City of Ontario

ADDENDUM NO. 8 Bid Invitation # 1900

TODAY'S DATE:	Monday, April 14, 2025
PROJECT TITLE:	D&C23-022 Ontario Sports Empire
BID PACKAGE:	D&C23-022 Ontario Sports Empire (BC03 & BC18)
BID CLOSING DATE:	April 17, 2025 at 2 p.m. No Change
CITY RESPONSE:	April 10, 2025 No Change
Q & A DEADLINE:	March 27, 2025 at 5 p.m. No Change
PRE-BID WALK:	March 12, 2025 at 8 a.m.

Project: Ontario Sports Empire

ROOF FRAMING (GREEN ROOM)
 SCALE: 1/4"=1'-0"
 S8.1

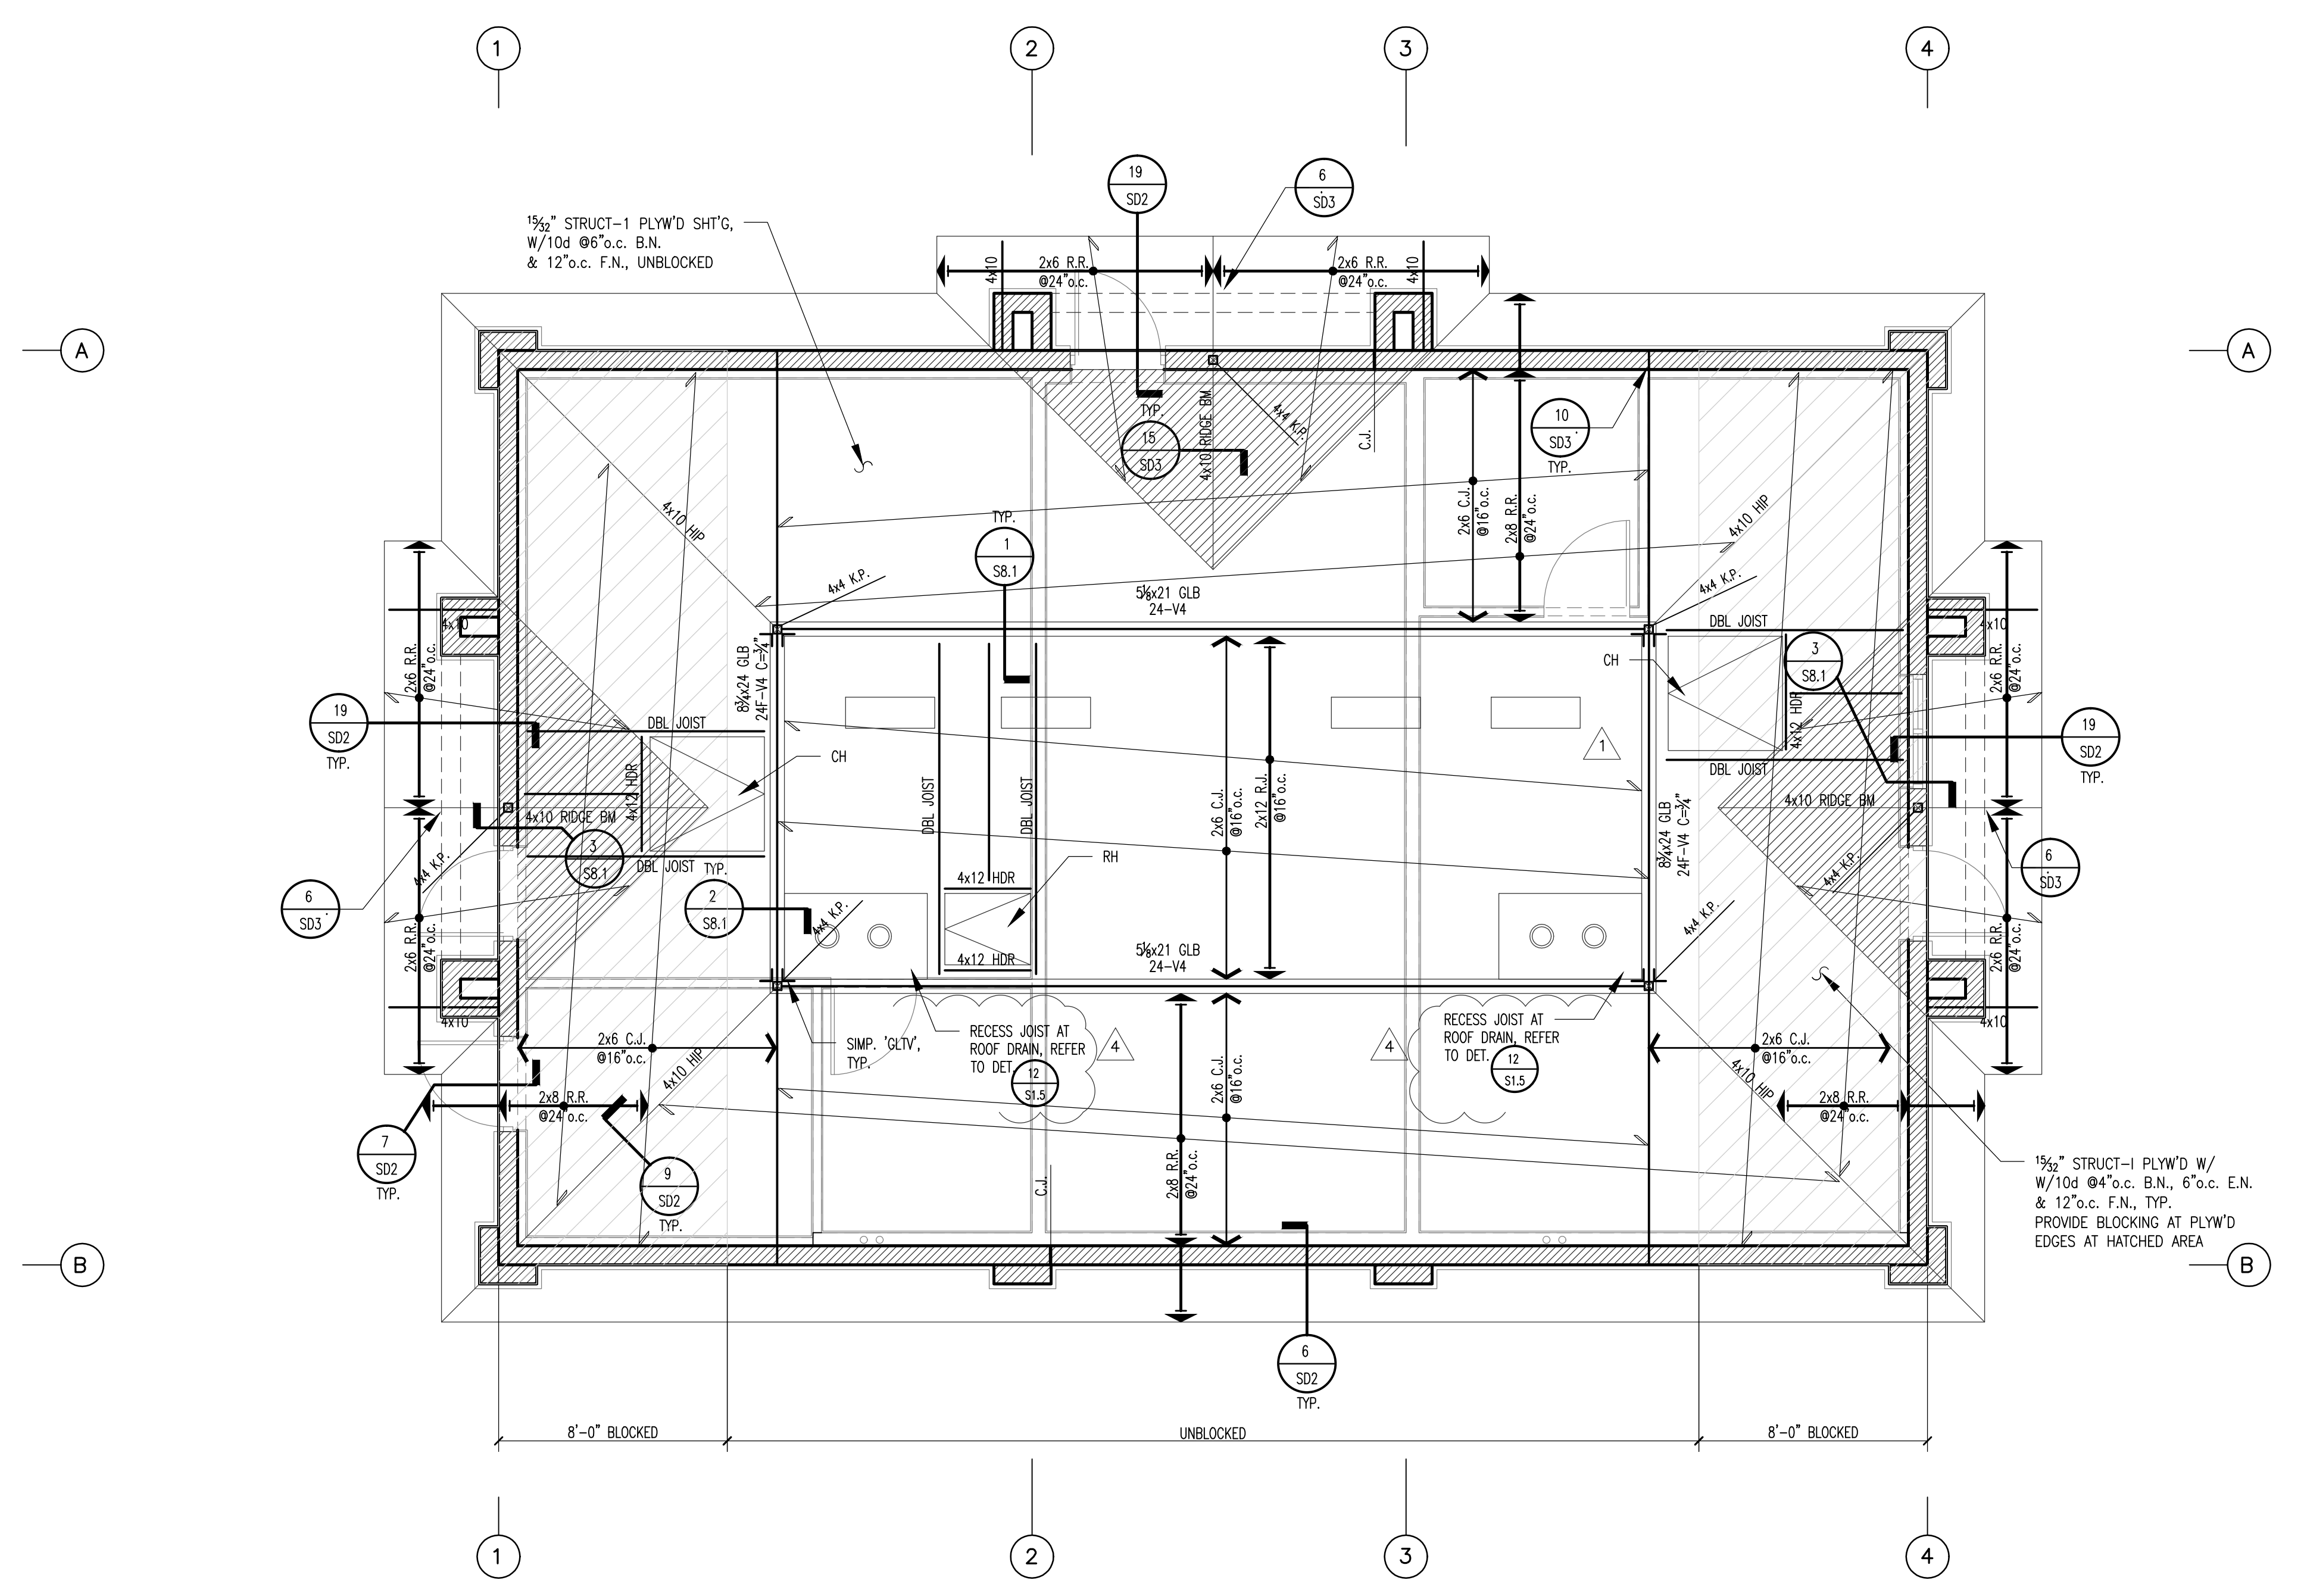
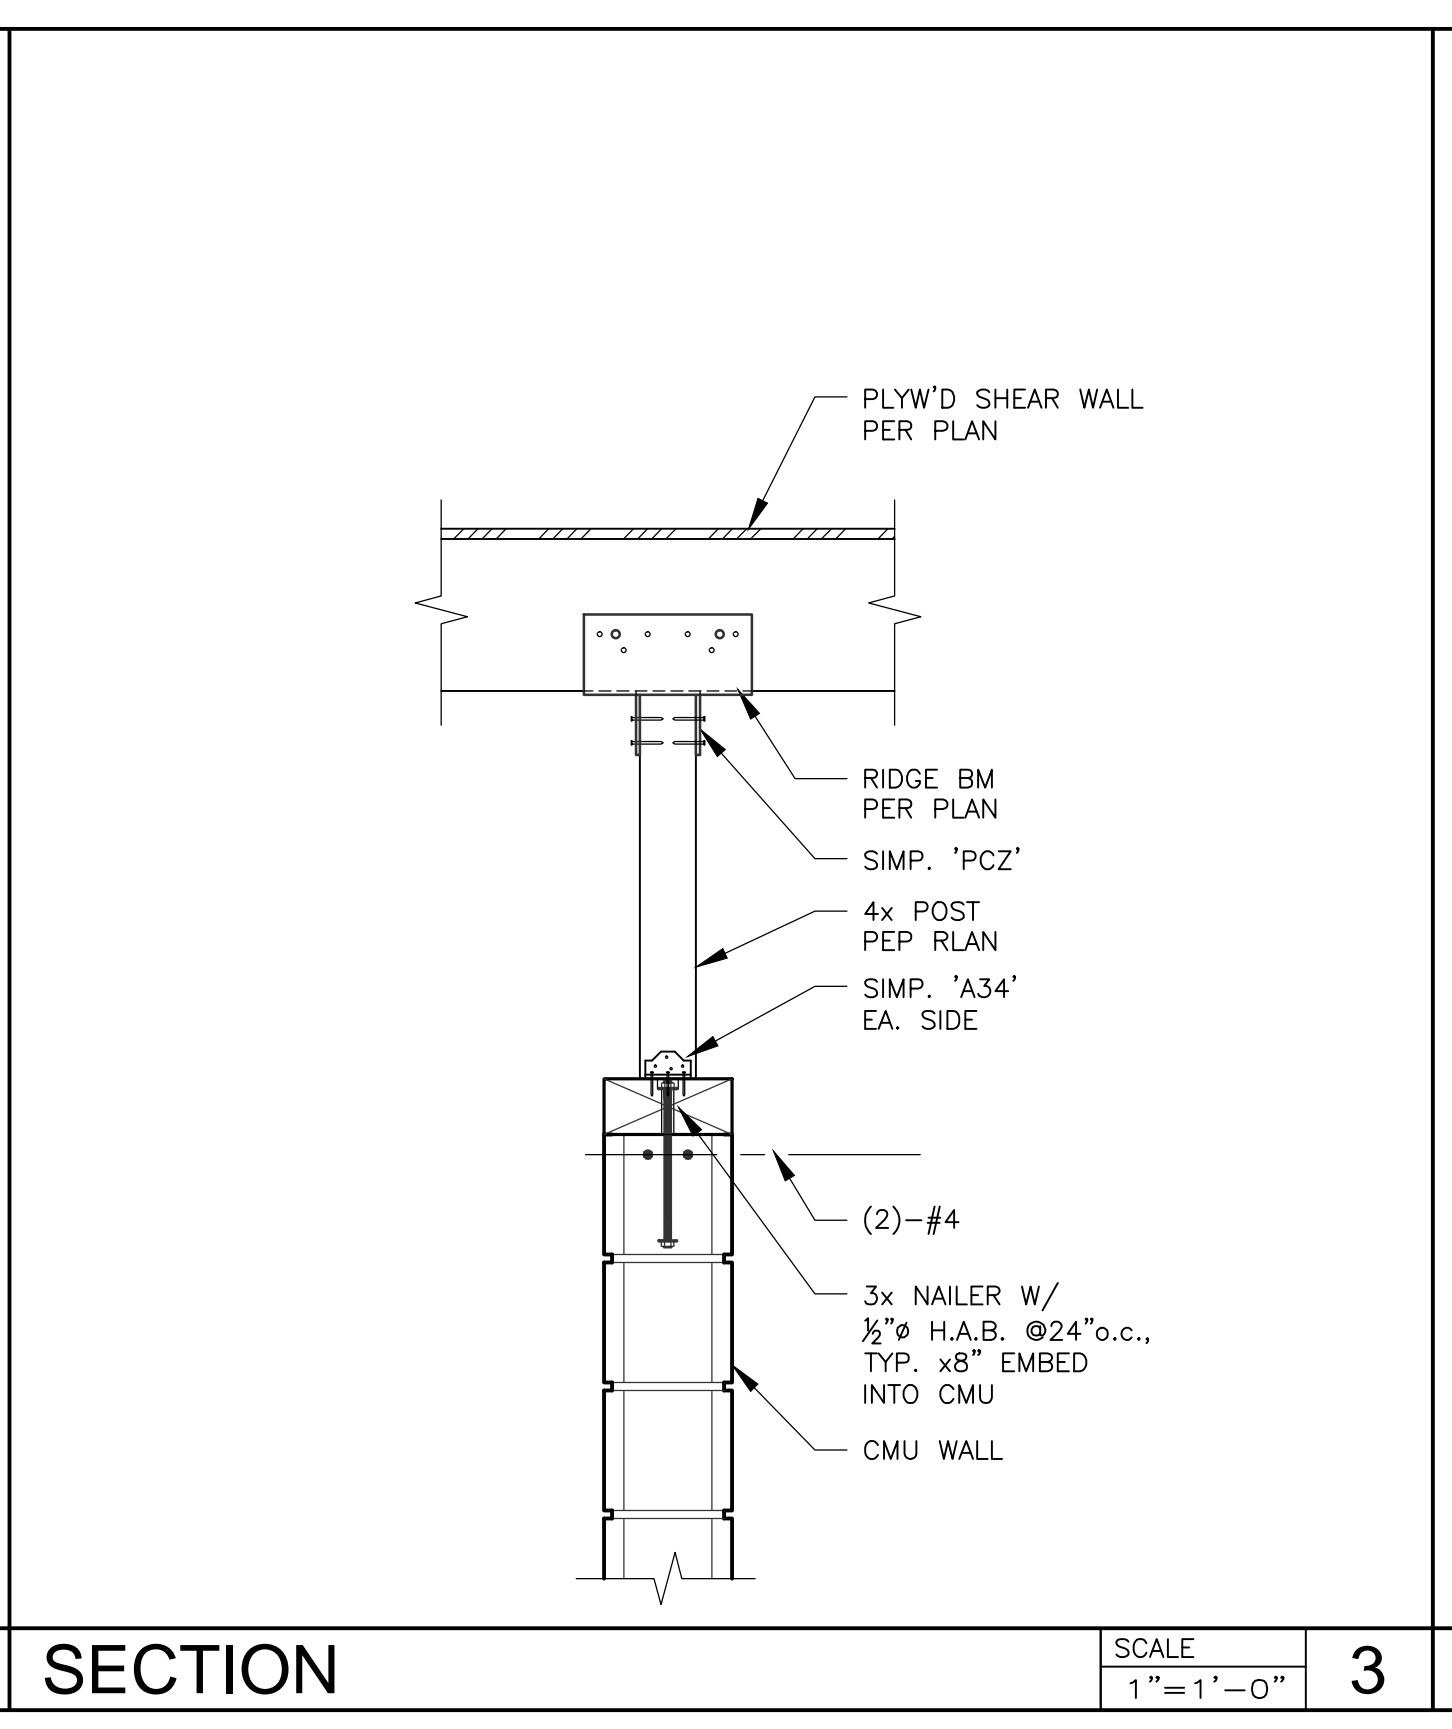
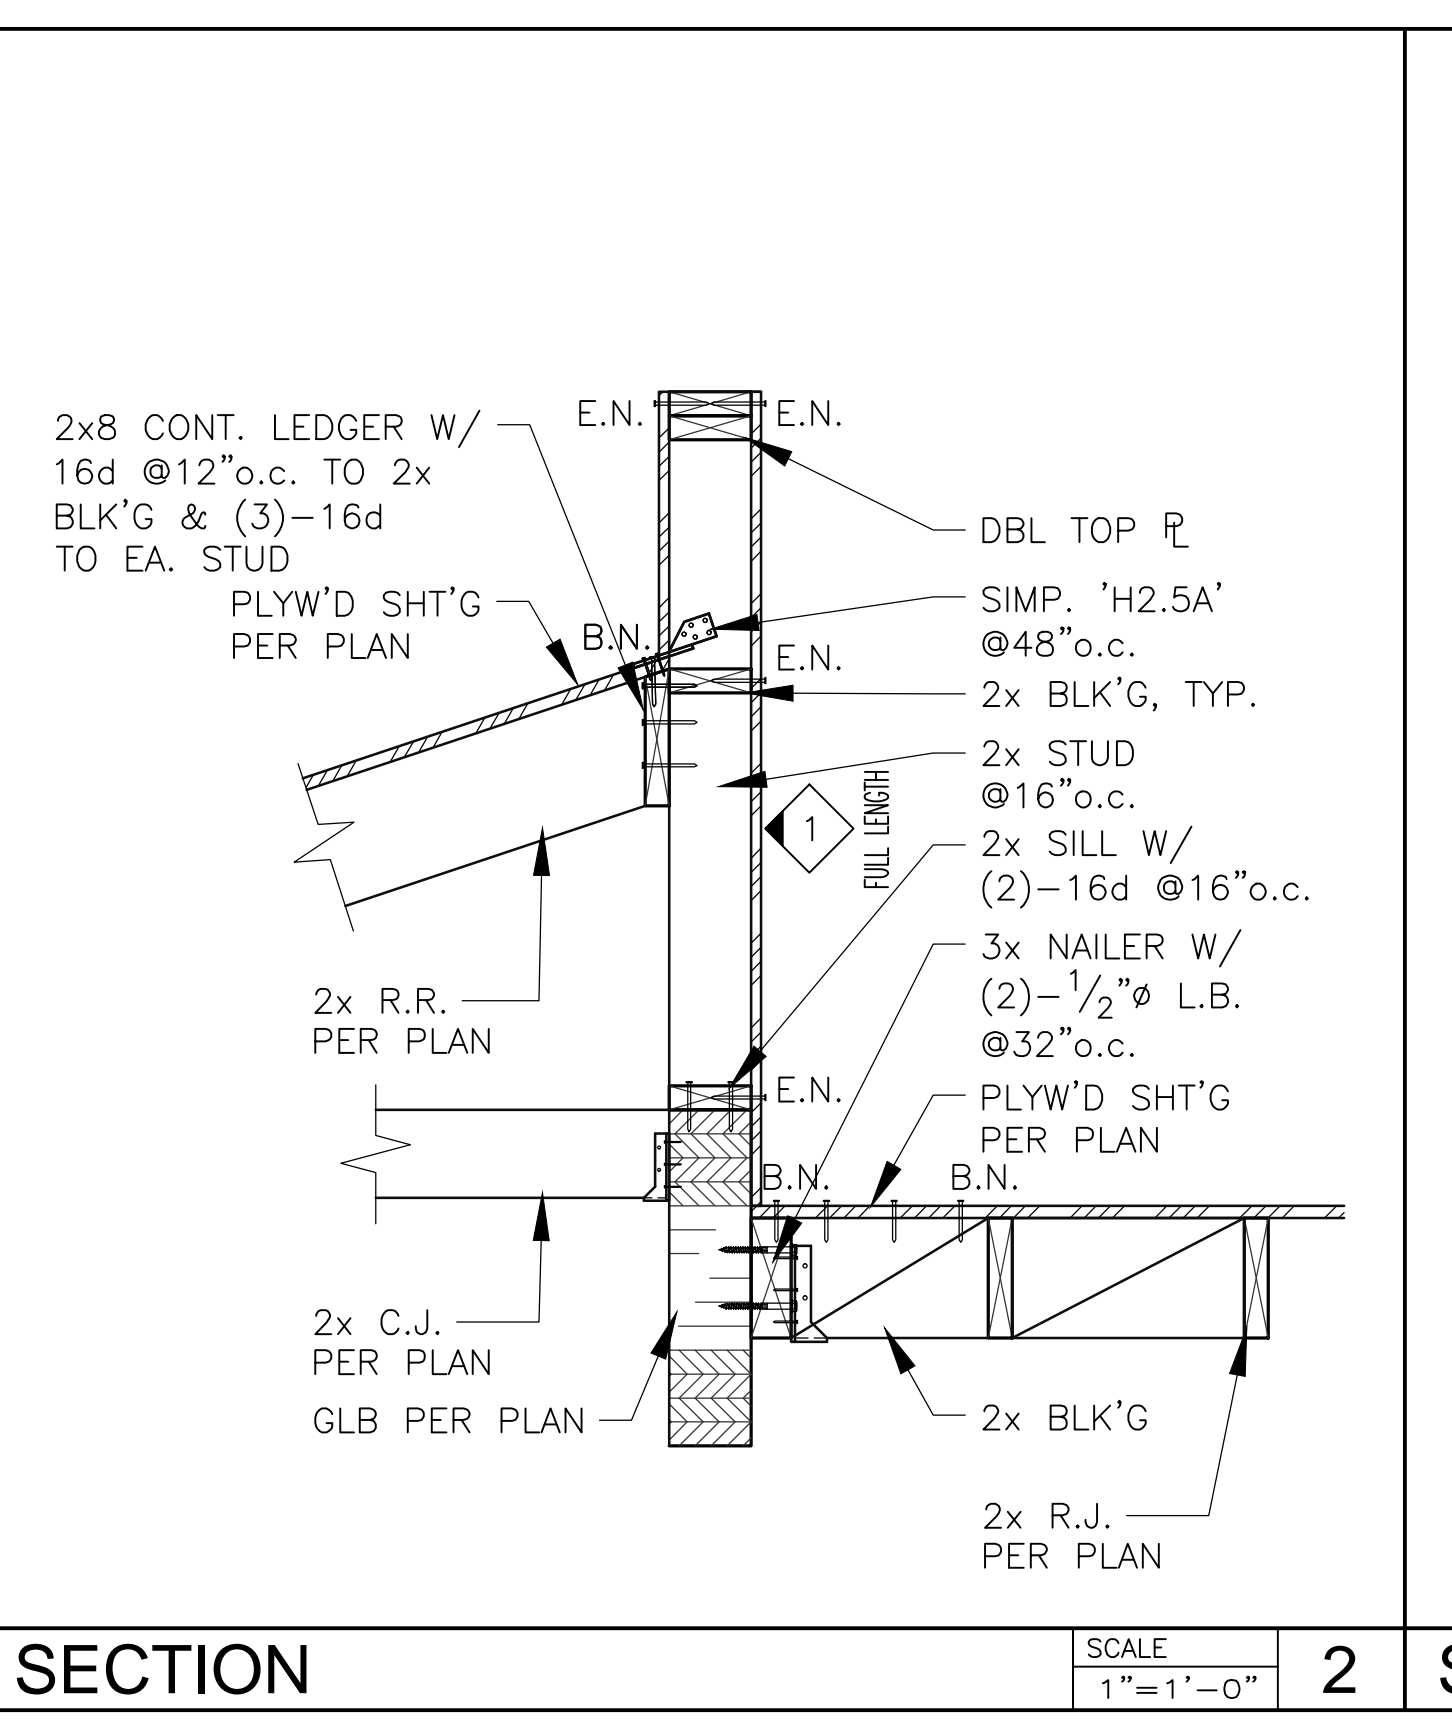
Green Room Building Mechanical Well, a) Where DBL joist are noted provide the size. b) Please note the locations for the roof & overflow drains. Would detail 12/S1.5 apply for the framing? Reference S8.1

A. USE DBL 2x6 CJ @16"o.c. NOTED PER PLAN.
B. ROOF & OVERFLOW DRAINS PER ARCHITECTURAL DRAWINGS ADDED ON S8.1. SIMILAR TO 12/S1.5. REFER TO ATTACHED DETAIL.
